# UNITED STATES PATENT AND TRADEMARK OFFICE

APPLICATION NO.	FILING DATE	FIRST NAMED INVENTOR	ATTORNEY DOCKET NO.	CONFIRMATION NO.
10/720,563	11/24/2003	Mutsumi Matsuura	051319/0077	5730

Title: COIL BOBBIN STRUCTURE  
Inventors: Matsumi MATSUURA and Genta YOSHII  
Serial No.: 10/720,563— Filed: November 24, 2003  
Schulte Roth & Zabel, LLP — John J. Skinner, Jr.  
Atty. Ref.: 051319/0077

FIG. 8  
PRIOR ART

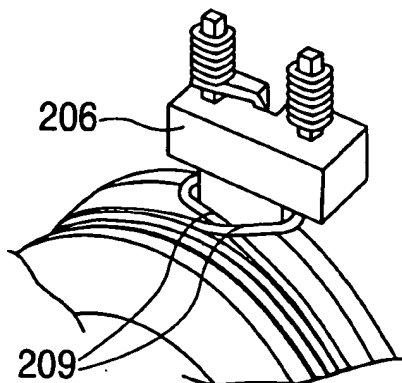
Claims 1-3 are rejected under 35 U.S.C. 102(b) as being anticipated by Applicant's Prior Art figures 6-8.

The prior art figures disclose a bobbin main body having flanges (104, 105) at both ends in the axial direction of a cylindrical winding drum portion; two terminal supports (the two protrusions at 106 in Fig. 6 and 206 in Figs. 7 and 8), at a portion of one of the flanges protruding in the outer direction of the diameter direction, with a gap (gap between the supports) between the two terminal supports, the terminal supports being provided with two terminal pins 107 that are standing; a wire (109, 209) that is wound around the outer circumference of the winding drum portion of the bobbin main body, each end of which are respectively wound and fixed to the terminal pins; a coil bobbin structure in that the two terminal supports are installed and the terminal pins are provided respectively to each terminal support so as to be standing; and a guide groove (groove or step under each terminal support) is provided respectively to each terminal support, and wherein each extremity of the wire passes from the winding drum portion through the gap between both terminal supports (as in Fig. 7), is wound into each terminal support, passed through the guide groove, is guided to the terminal pin and is wound and fixed to the terminal pin.

In reply to the remarks bridging pages 6 to 7 regarding the two terminal supports, Prior Art figure 6, for example, clearly shows a support for each pin. Nothing in the language of the claims precludes a unitary structure.
